**Arborist Report**

Site: 5 Degrees, Shoreline WA

Date: April 9, 2021, Revised August 26, 2021 (changes highlighted)

This addendum is in addition to the revised arborist report, authored by me, revised April 9, 2021. This addendum intends to clarify the information stated in that report and correct inconsistencies noted in the Correction Letter (PLN20-0139 Correction Letter 2 dated July 23, 2021).

EXISTING SITE PLAN  
 SHEET NO.:

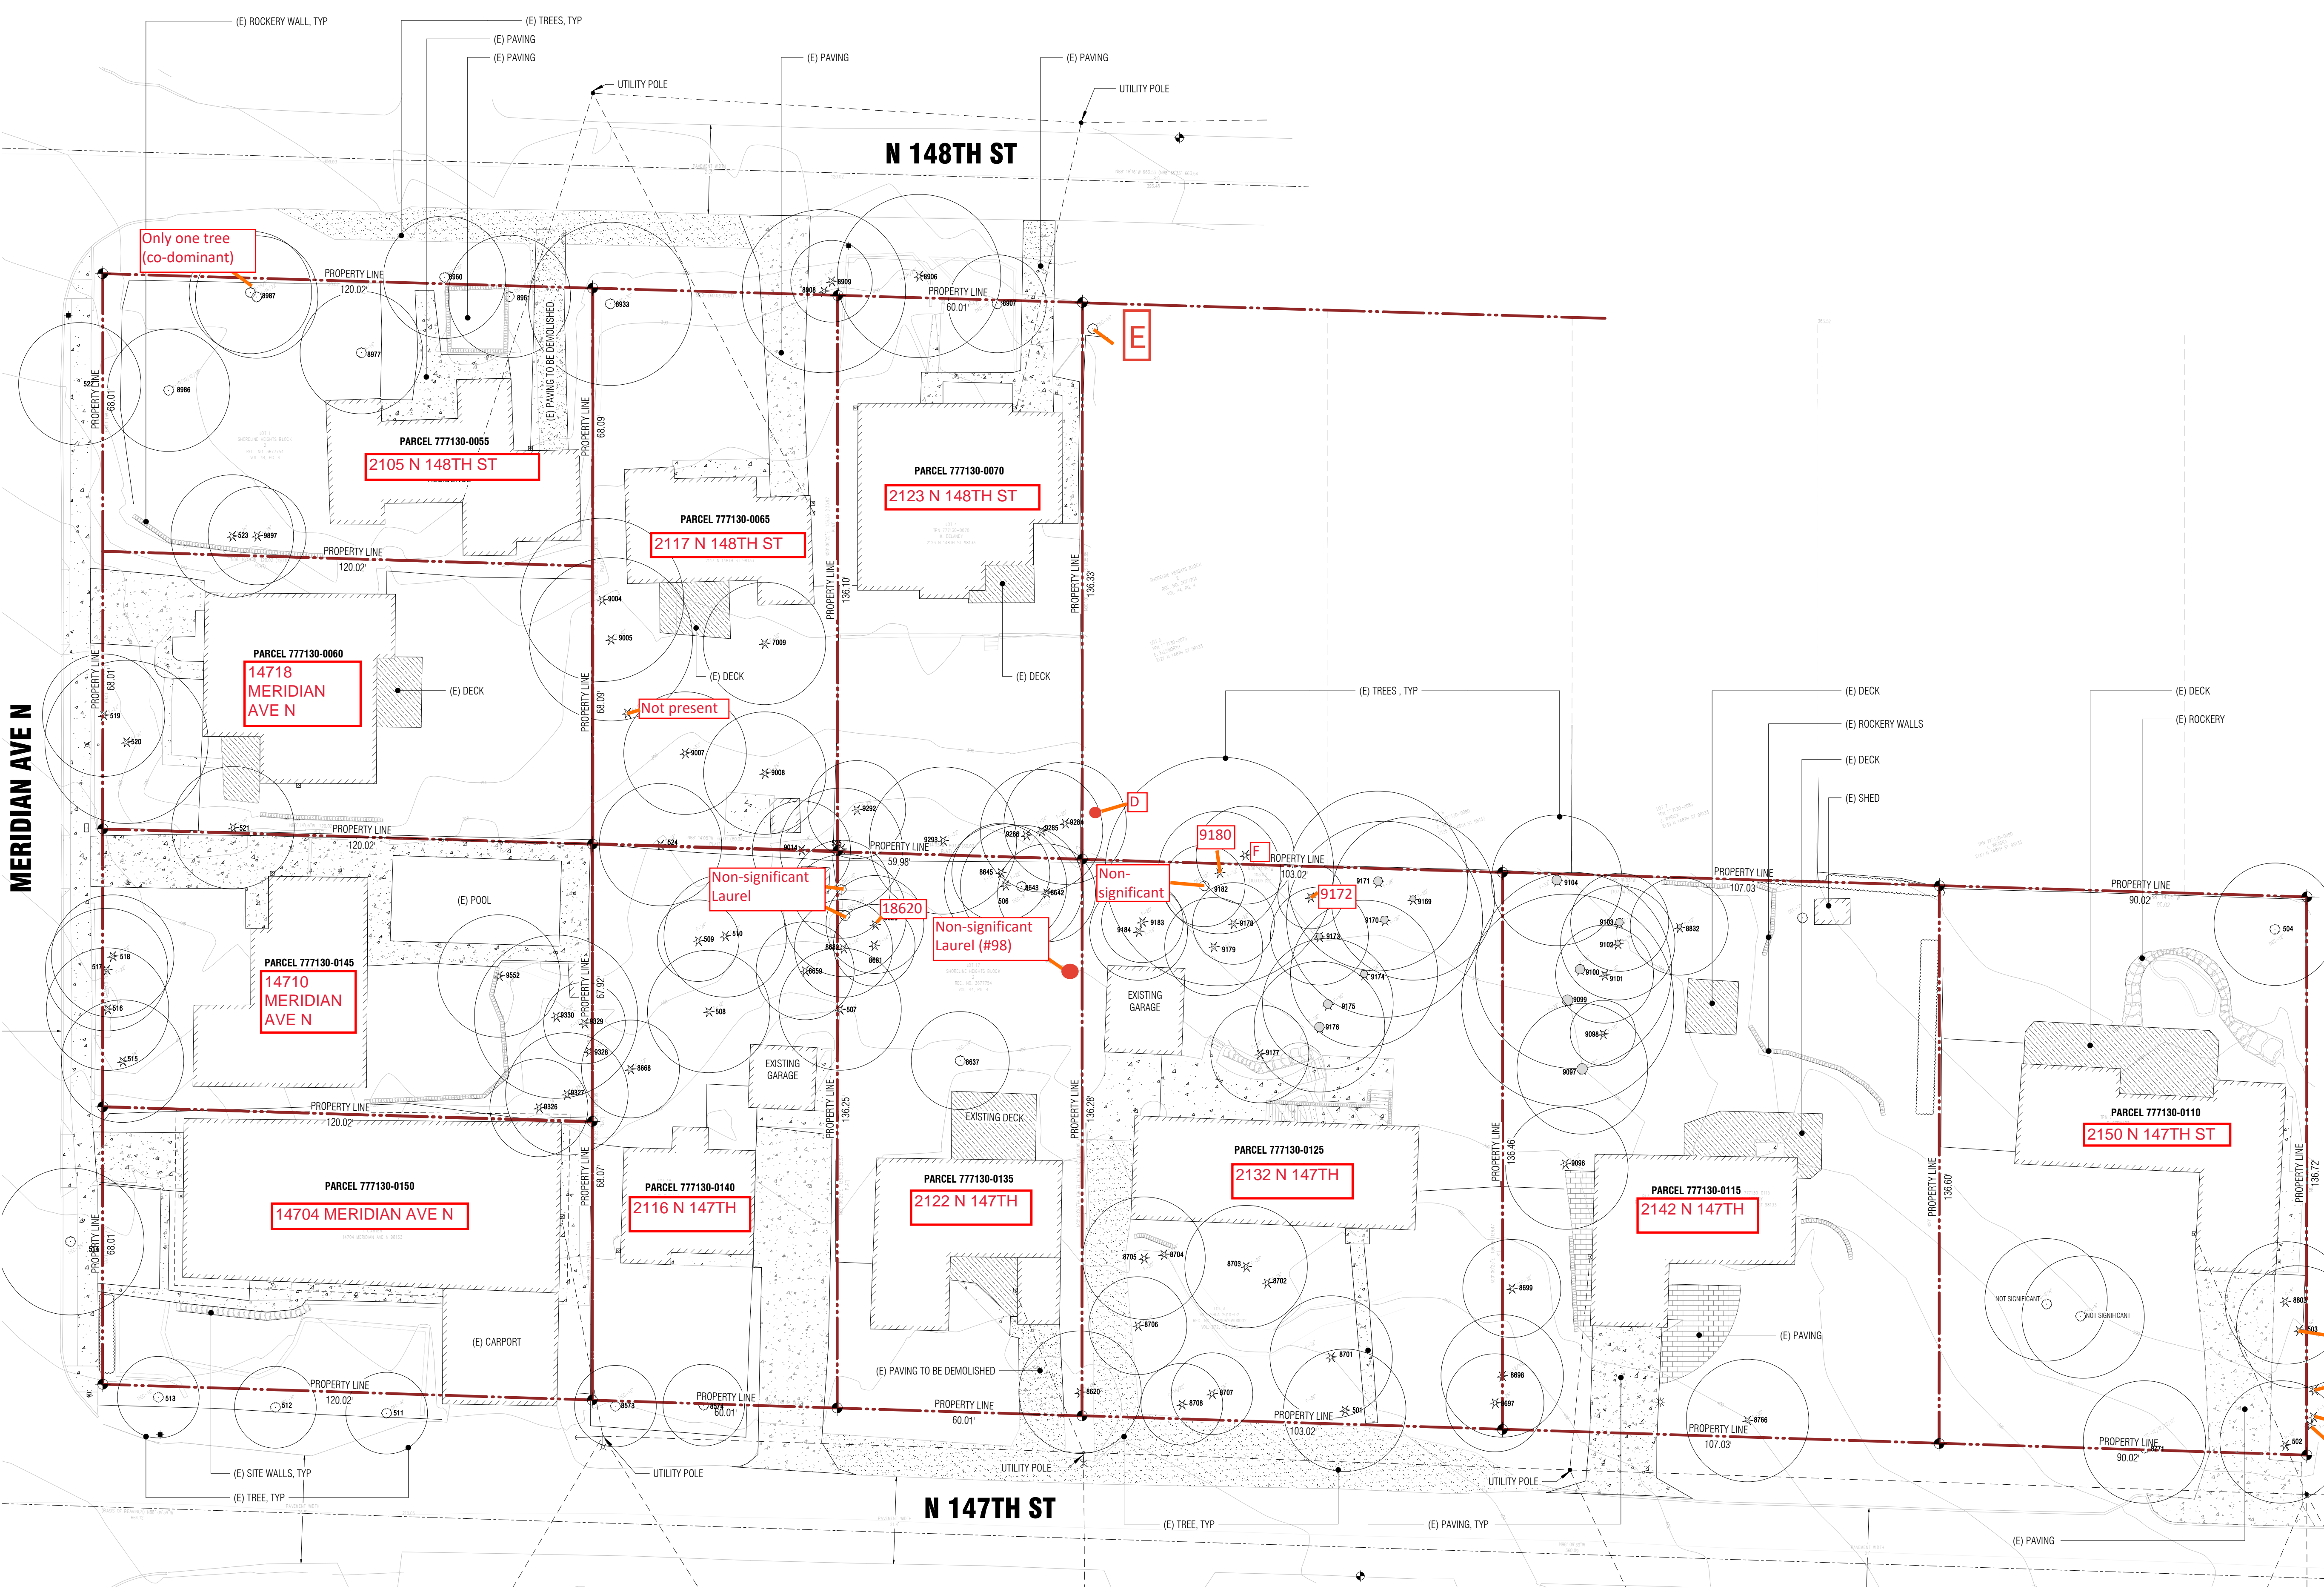
**26. There are three trees labeled #98 on Sheet L0.1. Please clarify/correct plans. I recommend doing a quality control check before submitting the next revisions to make sure there are no other instances like this—when I do my follow-up site visit for trees items like this should be addressed.**

**28 C. The arborist report states that a 9-foot TPZ is needed for Tree E, but Sheet L0.1 shows only a 7-foot TPZ is provided. Revise plans to comply with arborist report.**

**31. There are still issues with trees proposed for retention being adequately protected per the arborist report and what is shown on Sheet L0.1. See table below. Please address these discrepancies in updated plans/arborist addendum.**

**Within the tree protection fencing area indicated on plans there is a path and landscaping proposed. The arborist report addresses this briefly on Pages 3-4 of**

Tree 98 is insignificant. Will be changed on plan to say 'not significant plant'.

I have modified the arborist tree table to allow disturbance within 7 ft of tree 'E'. I have approved this reduction because the existing area is heavily compacted and used as a driveway currently.

The allowable tree protection zone and dripline are differentiated on the arborist tree table. One column is labelled 'dripline' and one is labelled 'Allowable TPZ'. The reviewer's comment mistakenly calls out dripline measurements as the limits of disturbance instead of using the 'Allowable TPZ'.

I added language to the tree table to further define the limits of allowable disturbance. For this tree, disturbance can go as close to the tree as 15 feet (with tree protection fencing established as close as 14 feet). But where tree protection for this tree can increase to 25 feet, it should increase (e.g. parallel to the new driveway).

Fencing around preserved tree grove should have 2 locked gates to allow selective entry into this area and key should be kept with project engineer on site. All installation of paths and new plant material should be via hand methods, using wheelbarrows to transport materials.
